UNITED STATES PATENT AND TRADEMARK OFFICE

APPLICATION NO.	FILING DATE	FIRST NAMED INVENTOR	ATTORNEY DOCKET NO.	CONFIRMATION NO.
09/878,946	06/13/2001	Masahiko Kubota	35.C15453	3562

Office Action Summary

DETAILED ACTION

FIG. 55

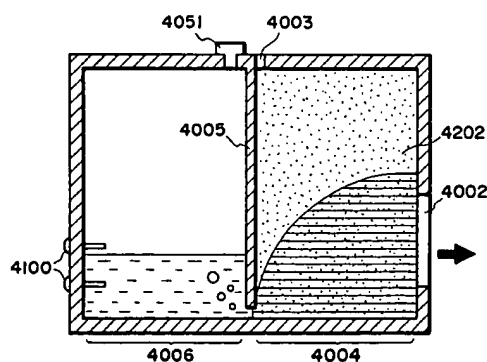
- {claim 53} a liquid container in which an ink to be supplied to a liquid ejection head for ejecting a liquid droplet is contained (See figures 1 and 55; column 1, lines 5-15); a first chamber which is partially connected to atmosphere and in which an absorber for absorbing a liquid is contained (See figure 15, references 3, 4, 13 and figure 55, reference 4004; column 20, lines 32-49); a second chamber which is closed from the outside and in which liquid is contained (See figure 15, references 6 and 9 and figure 55, reference 4006); a connection path, disposed in the vicinity of a bottom portion of the container, for connecting the first chamber to the second chamber (See figures 15 and 55, reference 8); a supply port which is disposed in the first chamber and via which the liquid is supplied to the liquid ejection head (See figure 15, reference 10 and figure 55); a first monitor means, disposed in the first chamber for monitoring a liquid amount of the first chamber (See figure 55, reference 4100; column 31, lines 23-53);

FIG. 20

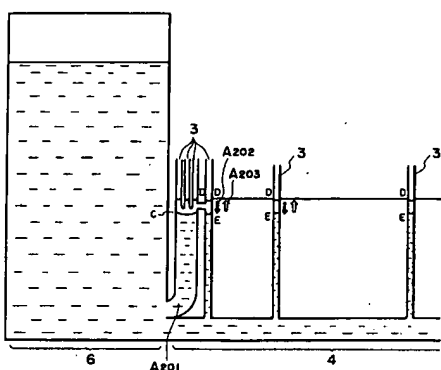
and a flow rate adjustment apparatus (in the form of a absorbing material acting as a valve), disposed in the connection path for adjusting a flow rate of the connection path (See figures 19-20, references 3, A201; column 17, lines 54-67; column 18, lines 1-9).

The applicant previously asserted that “Koitabashi is only seen to teach that absorbing material 4202 can be refilled continuously with ink. (Koitabashi, Figure 20; and column 31, lines 54 to 58). The absorbing material of Koitabashi is not seen to be a flow rate adjustment apparatus disposed in the connection path between the two chambers, much less a flow rate adjustment apparatus that is a solid semiconductor as in amended independent claim 53.” However, Koitabashi discloses “On the other hand, the liquid surface in the absorbing material rises because of the ink absorbed from the ink container, so that the liquid surface D is established, and the air-liquid exchange stops. In this state, there is no ink in the air introduction passage A201, and the absorbing material above the air introduction passage in the model, functions simply as a valve. If the ink is consumed again in this state, the liquid surface in the absorbing material lowers slightly, which corresponds to opening of the valve, so that the air-liquid exchange occurs at once to permit consumption of the ink from the ink container 6. Upon completion of the ink consumption, the liquid surface of the absorbing material rises due to the capillary force of the absorbing material. When it reaches the position D, the air-liquid exchange stops, so that the liquid surface is stabilized at that position.” (column 17, lines 54-67; column 18, lines 1-9). This clearly shows Koitabashi et al acting as a flow rate adjustment apparatus.

FIG. 2

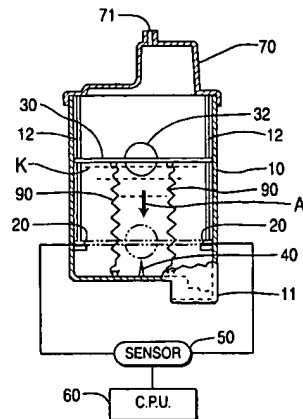
Ahn does disclose, with respect to claim 56, a sensing element disposed above a liquid surface (See figure 2, references 30 and 32; column 4, lines 51-65).

It would have been obvious to one having ordinary skill in the art at the time the invention was made to apply the teachings of Ahn to the invention of Koitabashi et al, in view of Maurelli et al and Arai et al, by configuring the first solid semiconductor element so that it is disposed above a liquid surface of the first chamber when a liquid supply to the first chamber from the second chamber is possibly interrupted. The motivation for the skilled artisan in doing so is to gain the benefit of being able to detect pressure fluctuation in this position (as taught above by Maurelli).
